Thank you to two anonymous reviewers and the editor for the detailed and helpful comments listed below in black. Our responses to all feedback are listed in red, below.

**First review:**

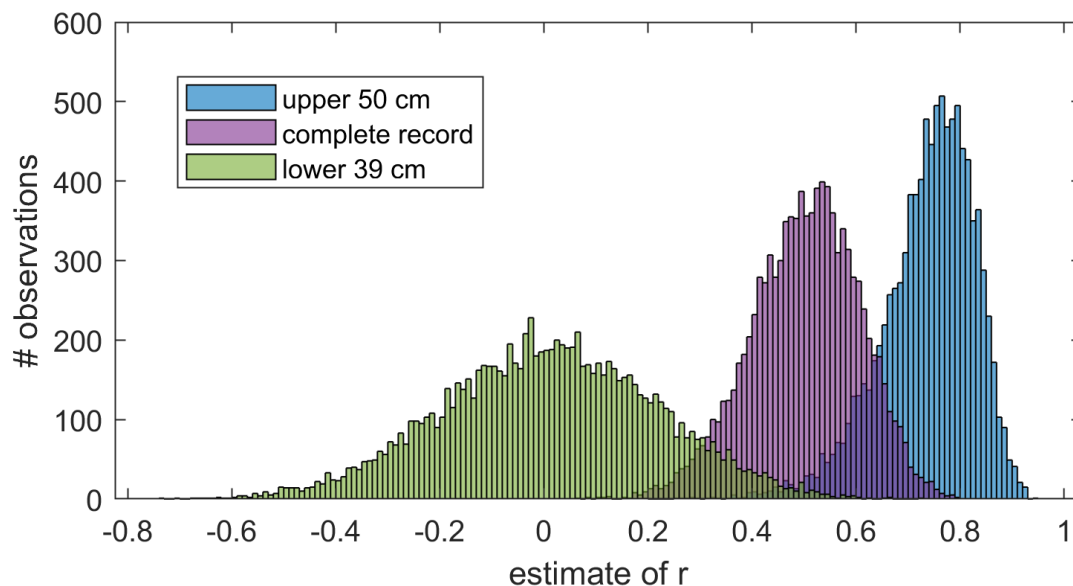
I. 318 + 319. The statements on the correlation coefficient ( $r=0.52$  with 99% confidence) or ( $r=0.70$  with 99% confidence) are confusing. Since  $r$  has been estimated from the sample, it has been determined with an uncertainty and some range of  $r$ -values should be associated to the 99% confidence interval. But no such range is given -- or do  $r$ -values given with two significant digits mean that the range is smaller than  $\pm 0.005$ ? The uncertainty of  $r$  is particularly interesting for assessing the significance of the difference in  $r$  between the upper 50 cm of the core and the rest of the data.

Thank you for pointing this out; we agree that this was confusing. We have updated these statistics with the range of  $r$  estimates from a resampling experiment and listed them at a 95% confidence interval in the text. Additionally, the figure below captures the full range of estimated  $r$  values and demonstrates that in the upper portion of the core where the seasonal signal is most prominent, the range of  $r$  values is substantially different from the lower section of the core where the D17O signal is relatively flat in both discrete and CFA datasets.
